Kirtland Air Force Base (AFB) is pleased to submit the *Work Plan for Data Gap Monitoring Well Installation KAFB-106248 to KAFB-106252 and KAFB-106S10, Bulk Fuels Facility, Solid Waste Management Units (SWMU) ST-106/SS-111*, Kirtland AFB, New Mexico dated September 2020. This work plan has been revised in response to the NMED July 14, 2020 approval with modifications letter.

**WORK PLAN FOR DATA GAP MONITORING WELL
INSTALLATION KAFB-106248 to KAFB-106252 and
KAFB-106S10
BULK FUELS FACILITY
SOLID WASTE MANAGEMENT UNITS ST-106/SS-111**

1		APPENDICES
2	A	Historical Groundwater Information
3		A-1 Water-Level Hydrographs
4		A-2 Historical Groundwater Plume Maps
5		
6	B	Field Forms
7	C	Laboratory Method Reporting Limits and Screening Criteria
8	D	Response to Comments: New Mexico Environment Department, Hazardous Waste Bureau,
9		Approval with Modifications, July 14, 2020

Figure 4-1
Proposed Construction Diagram for Groundwater Monitoring
Well with Contingency Well

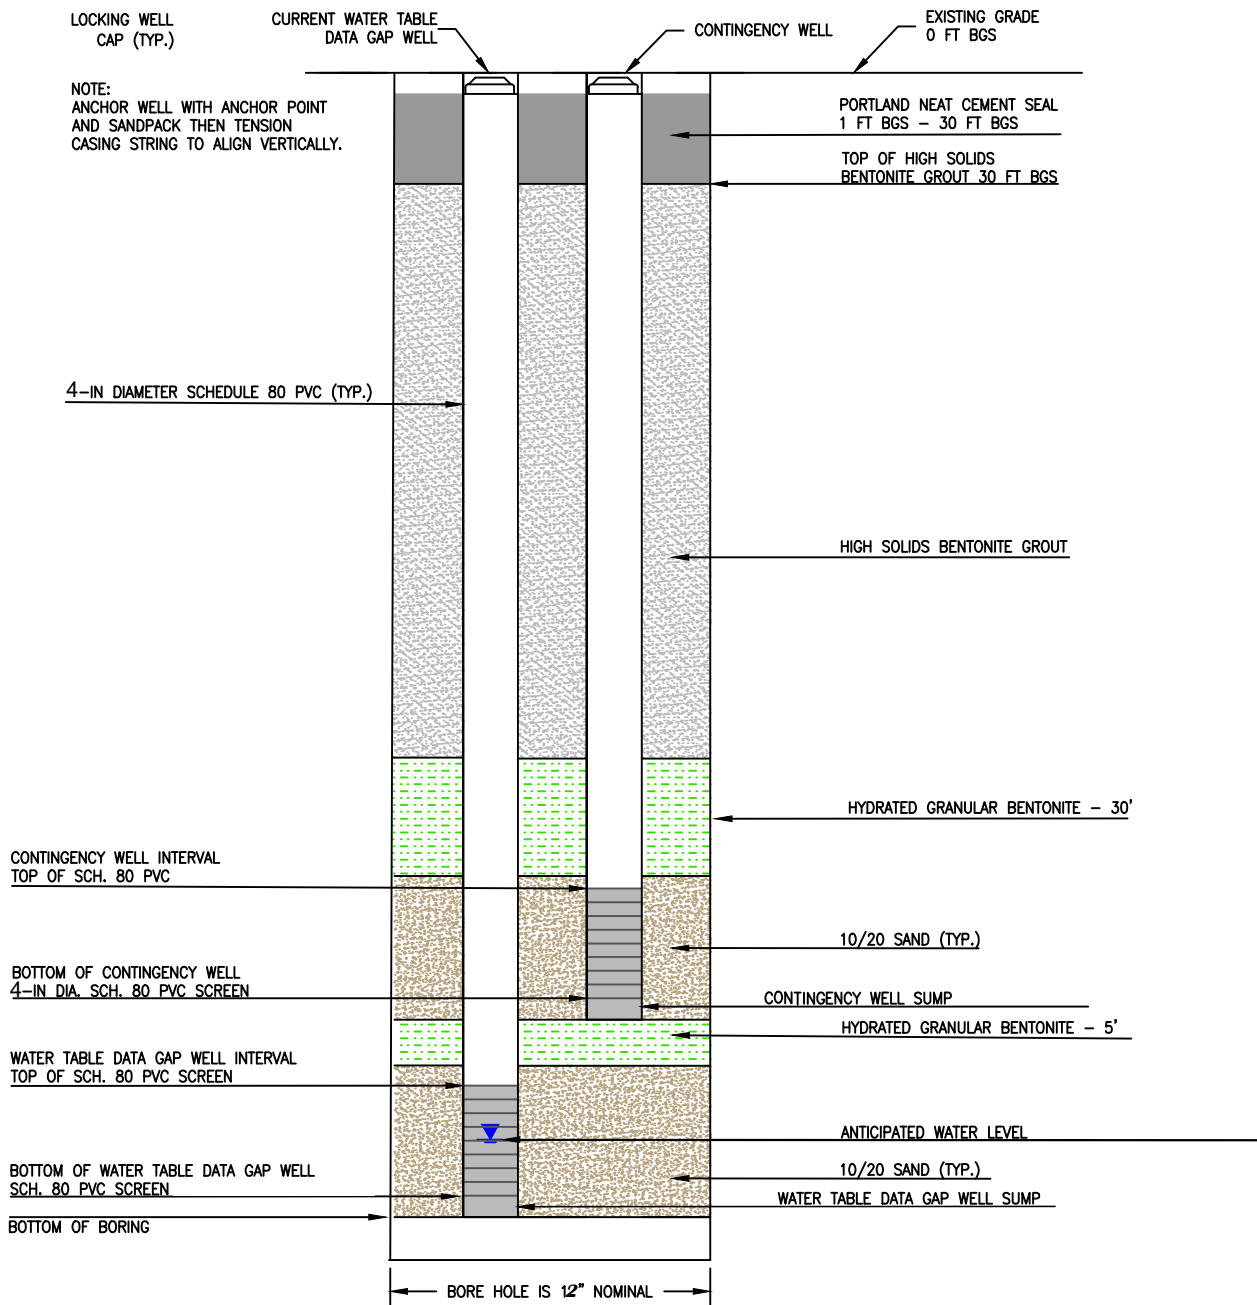
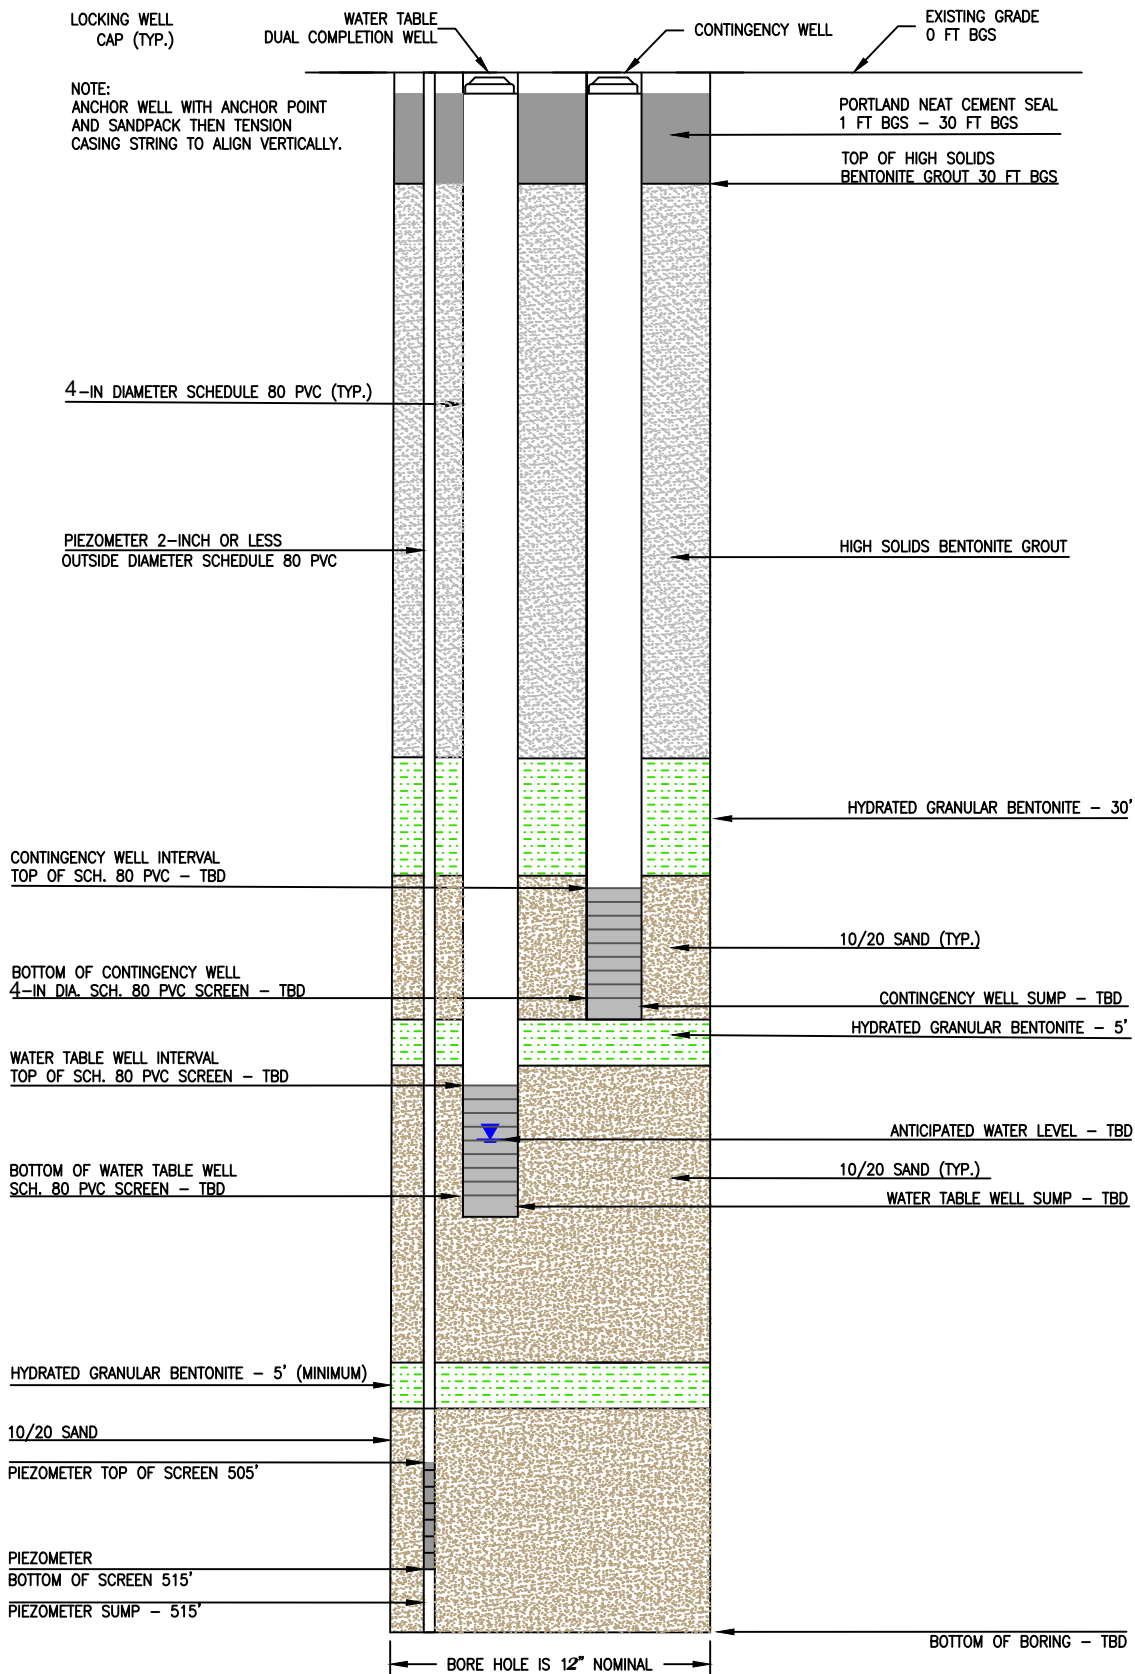
5	<p>Section 4.0, Scope of Activities, page 4-1, line 9 and Figure 4-1, Proposed Construction Diagram for Groundwater Monitoring Well with Contingency Well and Figure 4-2, Proposed Construction Diagram for Groundwater</p>		<p>Permittee Statement: "Four of the five proposed GWM wells (KAFB-106249 through KAFB- 106252) will be constructed with the same design employed by the Work Plan for Data Gap Monitoring Well Installation {Section 3.1.1of [Work Plan for Data Gap Well Installation, 2017]} as shown on the construction diagram {Figure 4-1}."</p> <p>NMED Comment: All groundwater monitoring wells must be constructed utilizing an appropriate well casing diameter (e.g., four-inch inside diameter) to accommodate equipment, such as low-flow pumps, which can effectively purge wells for active sampling.</p>	<p>Revised as requested - All planned GWM wells have been redesigned to accommodate active sampling techniques, including increasing inside diameter to 4 inches. All Sections have been revised to specify active sampling on all newly installed GWM wells.</p> <p>Figures 4-1 and 4-2 have been revised to reflect the well redesign.</p>

FIGURE A-1
GROUNDWATER ELEVATION CROSS SECTION

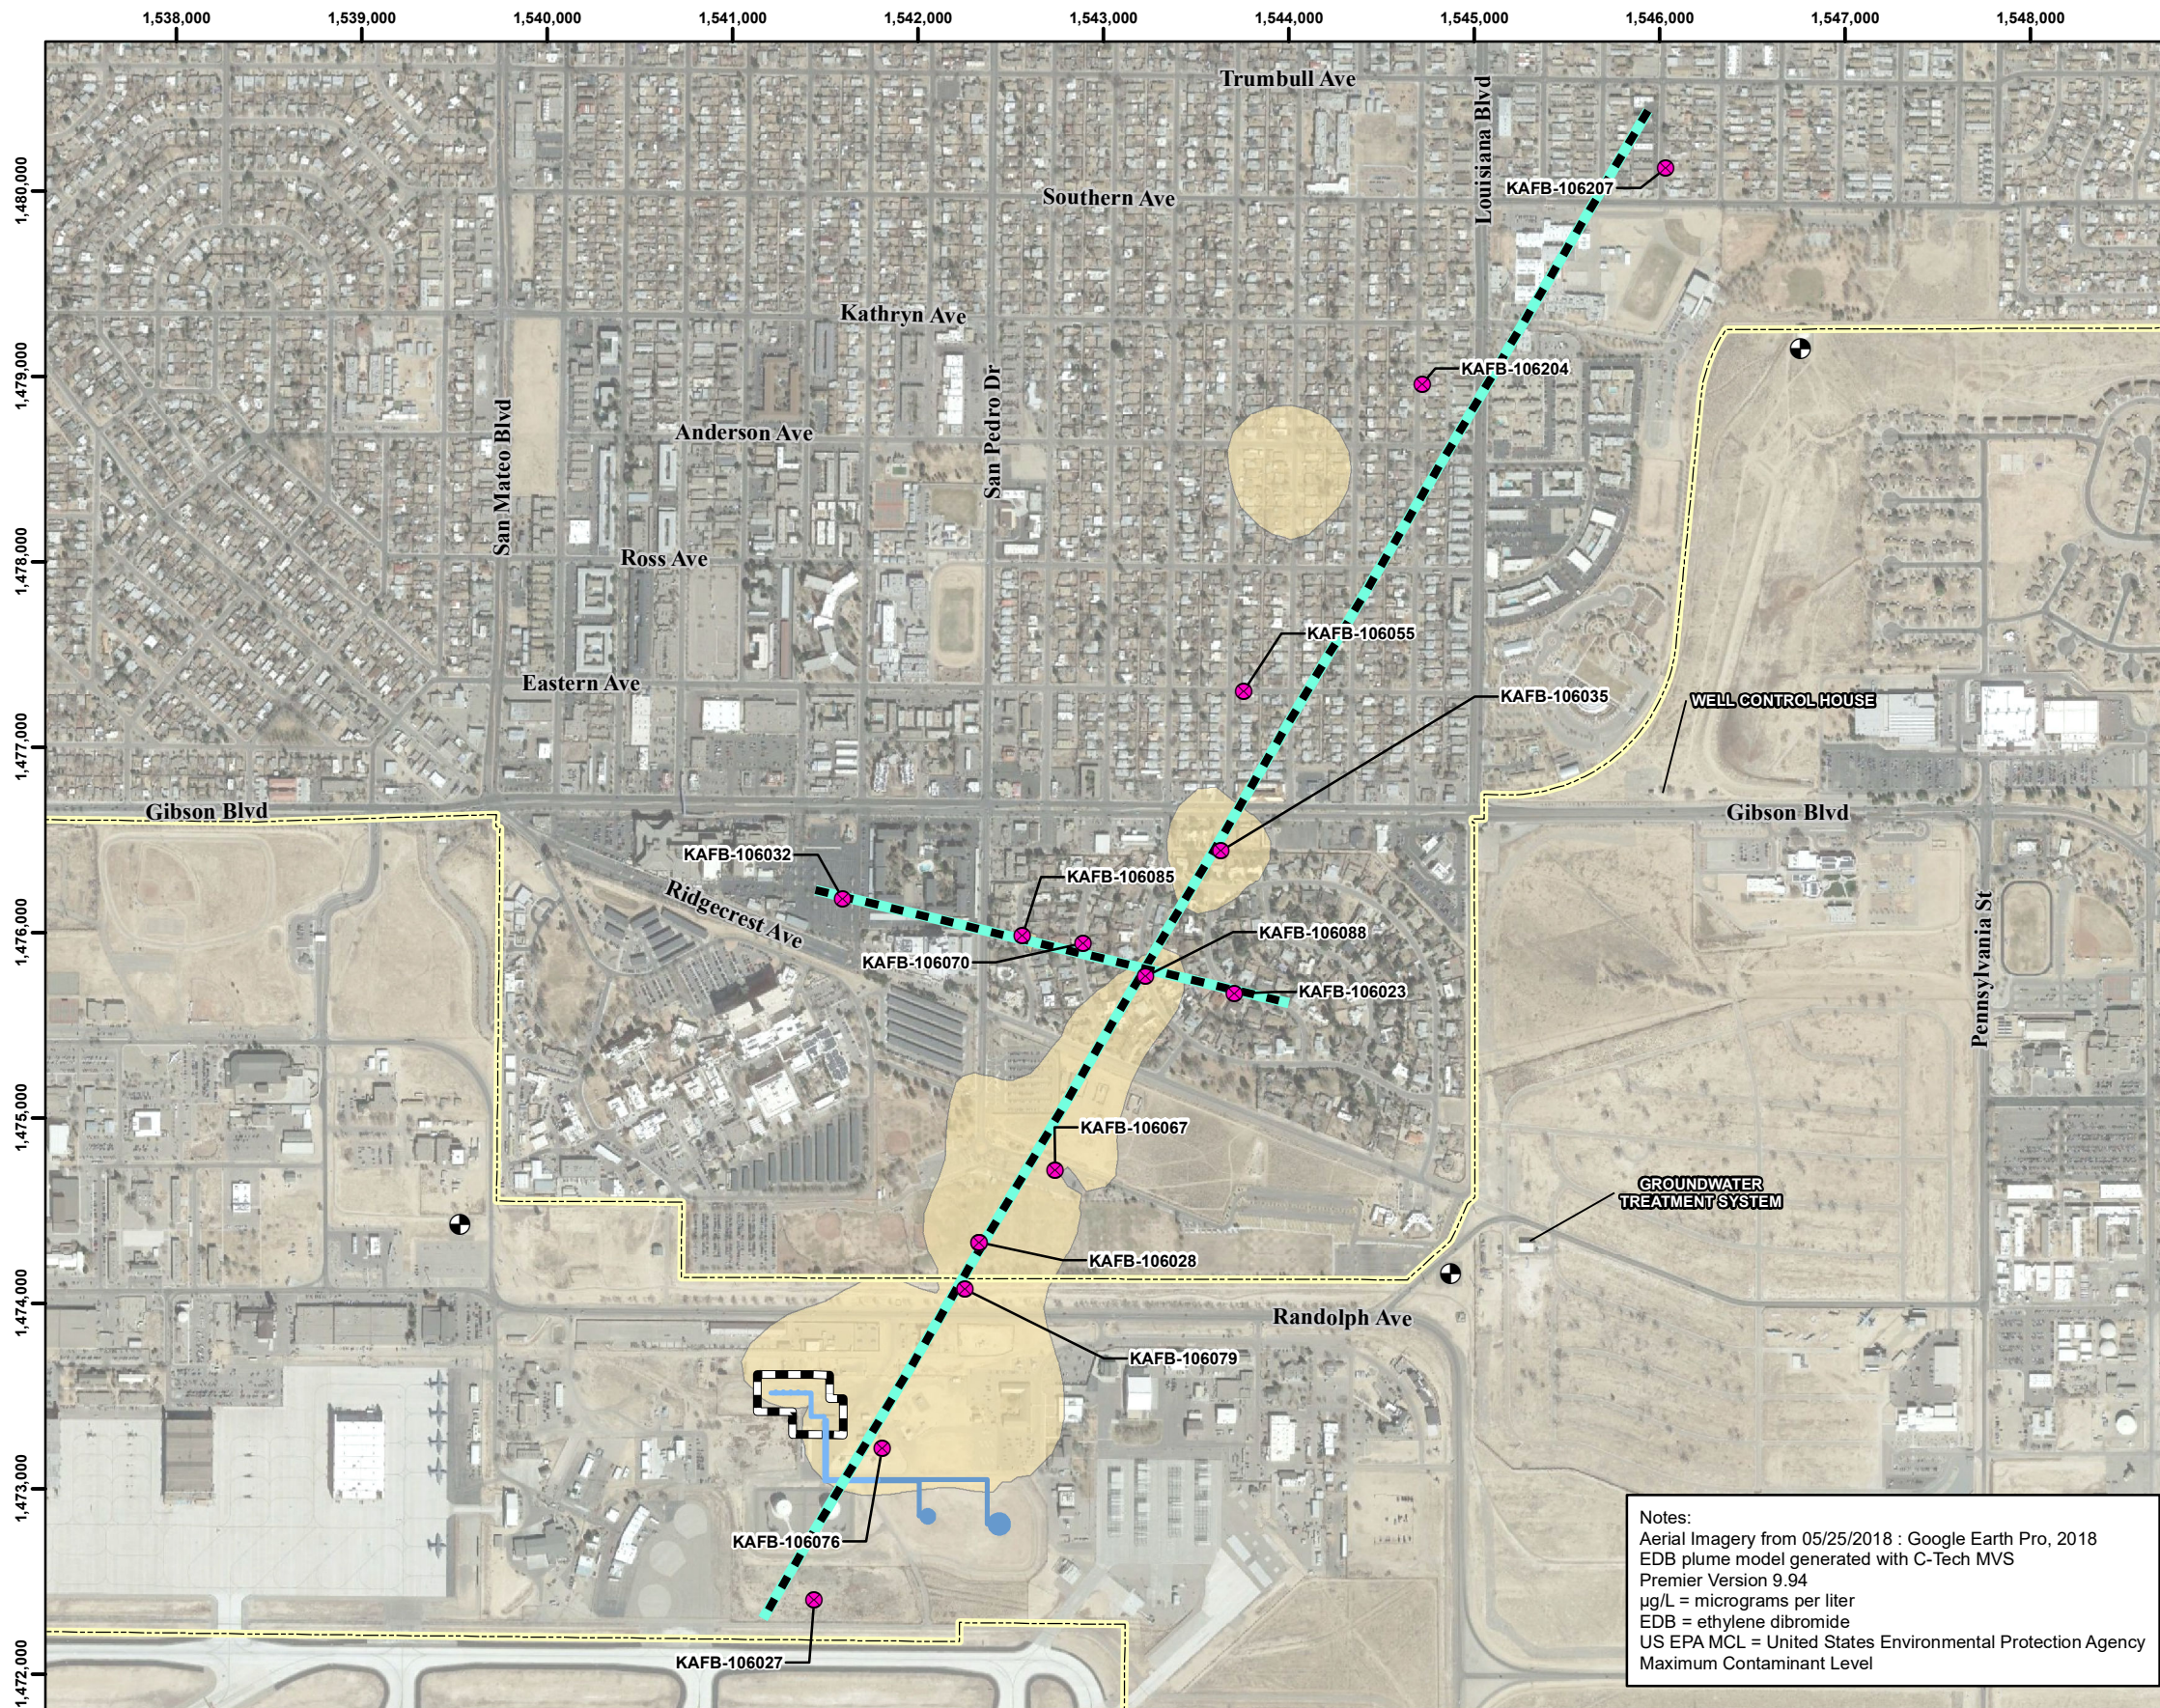
Item	Section	Page	Comment	Response
			a continual decrease in groundwater extraction at the Ridgecrest wellfield. NMED Comment: Appendix A-1 does not clearly depict this. See Comments 35 and 36.	
35	Section 3.0, Site Conditions, page 3-1, line 41		Permittee Statement: "Currently, these exceedances of EDB and benzene cannot be accurately bounded because GWM wells with non-detect concentrations of EDB and benzene to the southeast have submerged well screens." NMED Comment: According to Figures 2-1, Proposed Monitoring Well Locations and Q2 2019 EDB Plume Map, and Figure 2-2, Proposed Monitoring Well Locations and Q2 2019 Benzene Plume Map, the southeast boundaries of both the benzene and EDB plumes are bounded by groundwater monitoring wells KAFB-106245 and KAFB-106247, neither of which have submerged well screens. According to these figures it appears that the southern and southwestern boundaries of these plumes are not bounded by any wells which do not have submerged well screens. Proposed groundwater monitoring well KAFB-106252 will close the southern data gap, however, additional wells may need to be installed in the future to delineate the southwestern edge of these plumes. No response required.	Comment noted.
